# DTE Comments Summary on 802.3da D3.0

G. Zimmerman / CME Consulting (ADI, APL  
Group, Cisco, Infineon, Onsemi, Sony)

9/16/2025

# “DTE” comment group - summary

Figure 189-2 Example MPI Groups

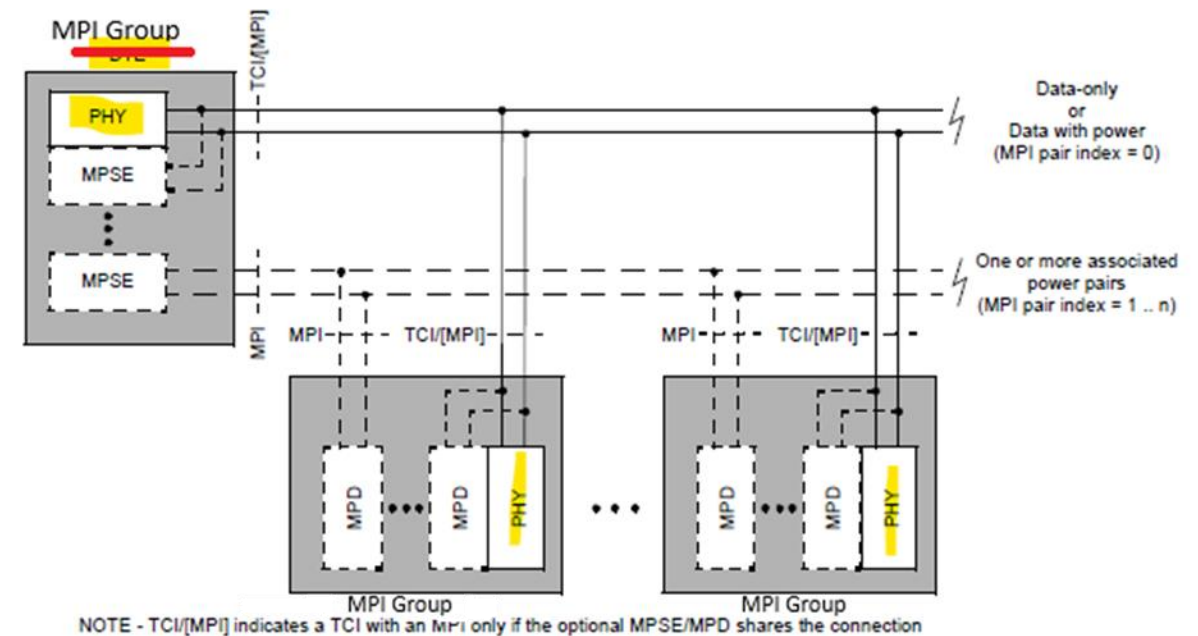
- Change title of Figure to “Example MPI Groups”
- Split “PHY” into “MAC client | MAC | PHY” (in each instance)
- Change label “DTE” to “MPI Group”, add label “MPI Group” below 2 lower boxes

Figure 189-6—Current at an MPD MPI

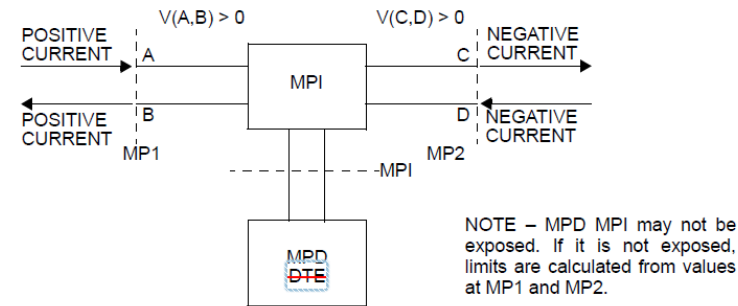
- 189.2 Mixing segment: DTE here refers to the physical device:
  - “attached DTE”, and “Each DTE includes mated connectors”
  - Replace with “device”
- 189.4.3 & 189.5.2: Figures include “DTE” in label, that adds no information...

# MPSE and MPD on same device

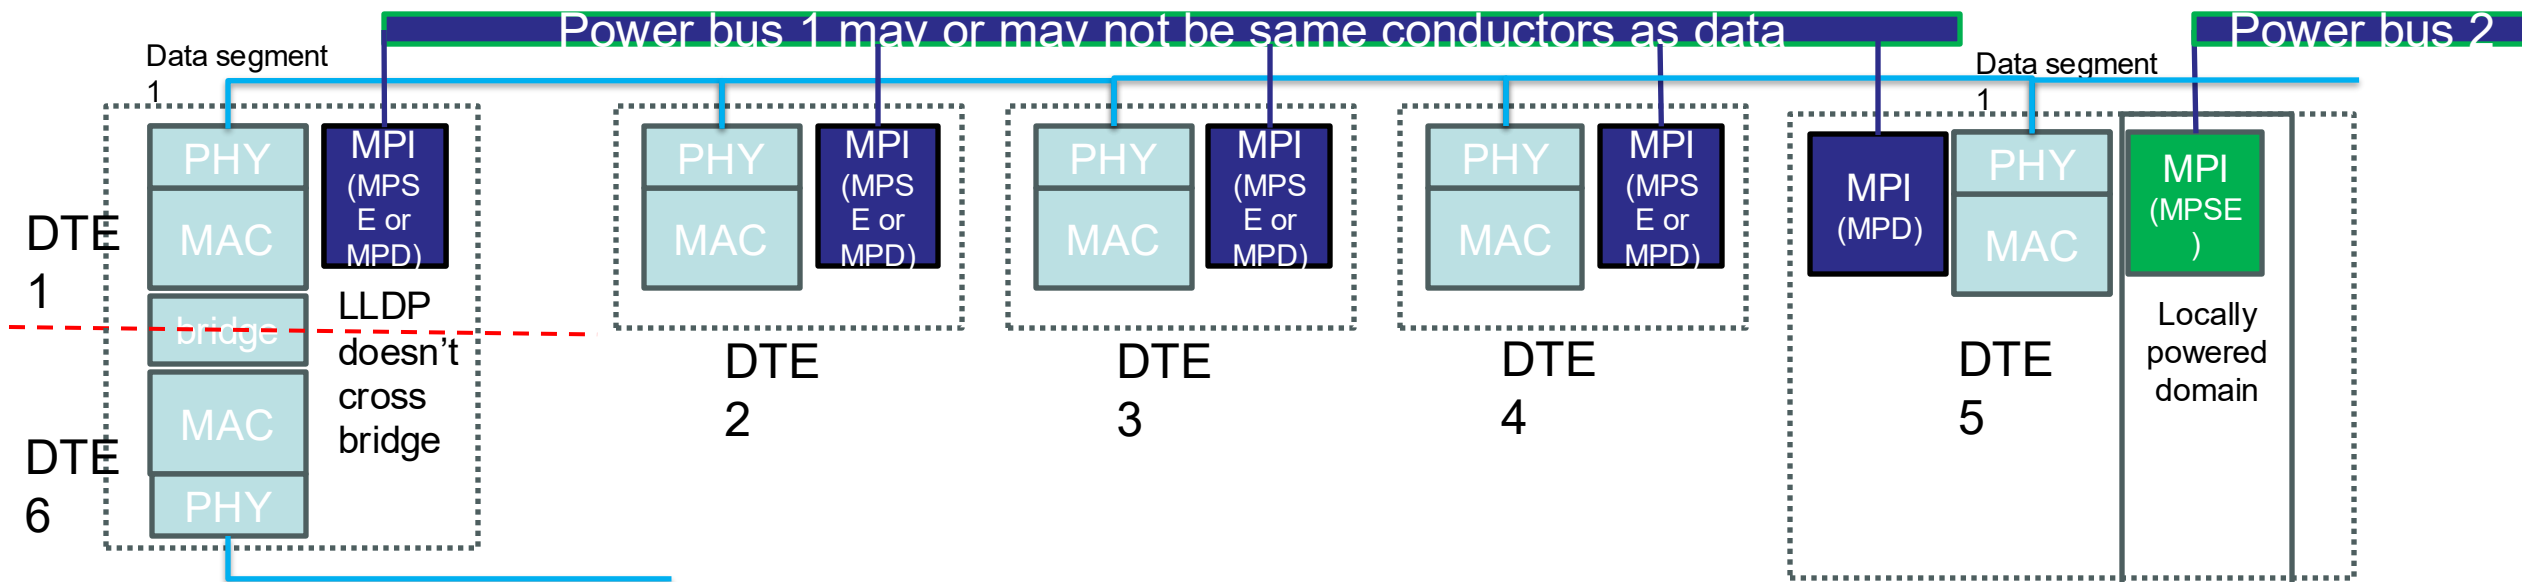
- One of the 2 power busses does not share same conductors as data
  - Shown as power bus 2 here
- MPD & MPSE on DTE5 are in same LLDP bridge group
  - This means LLDP management for power bus 2 is the same as power bus 1.
- Confusion because 2 power busses w/2 independent budgets are in the same LLDP domain

# Avoiding MPSE & MPD on a DTE doesn't fix it

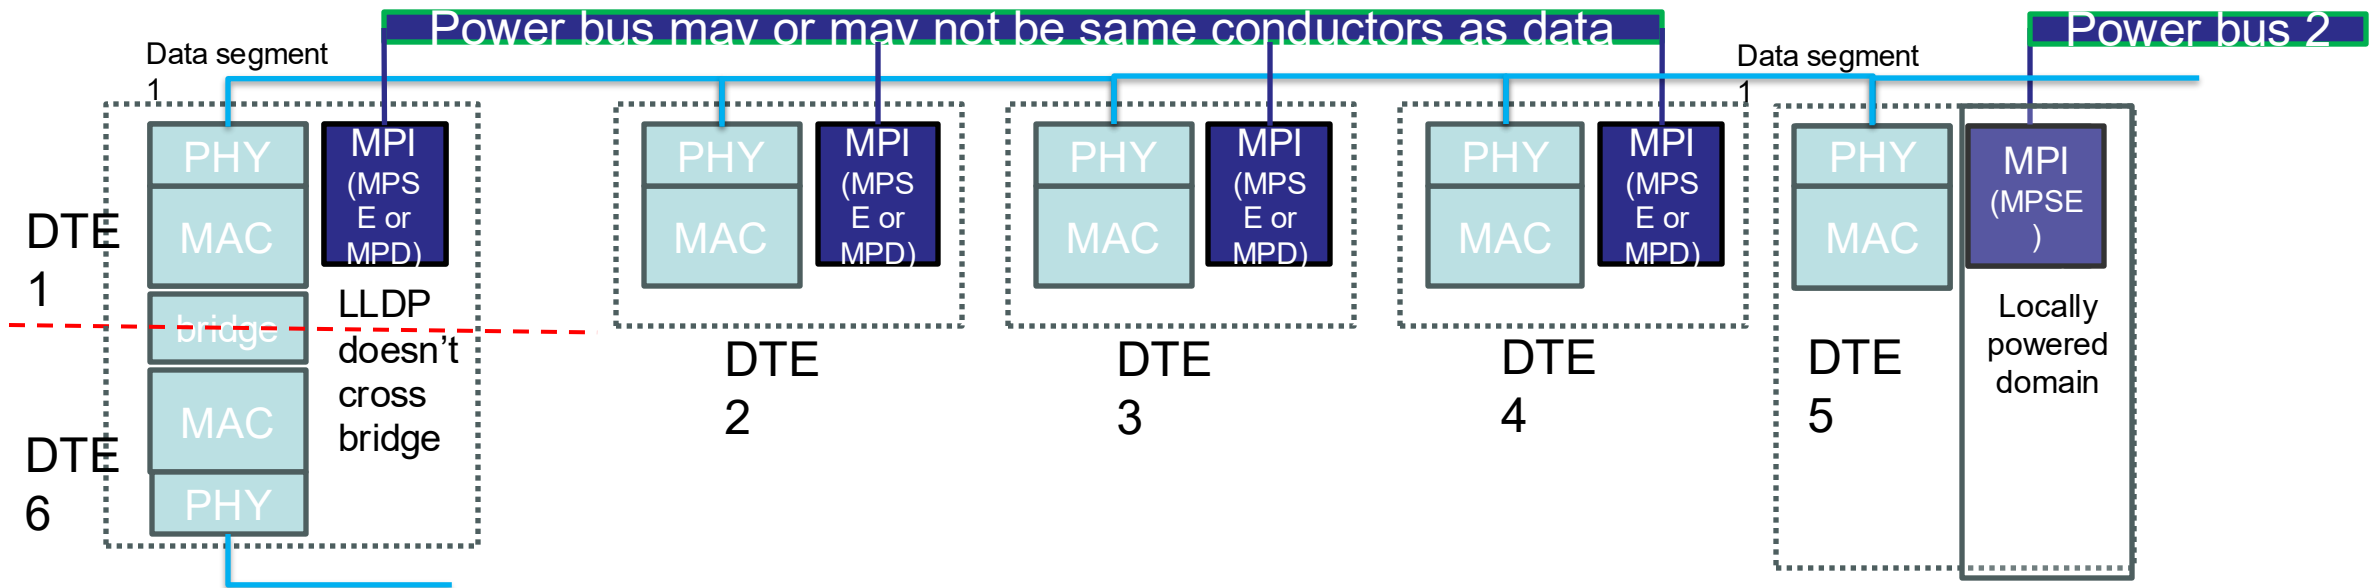
- One of the 2 power busses does not share same conductors as data
  - shown as power bus 2 here
- MPD & MPSE on DTE5 are in same LLDP domain as MPSE on power bus 1
  - Management confusion because 2 power busses w/ 2 separate MPSE power budgets are in the same LLDP bridge group
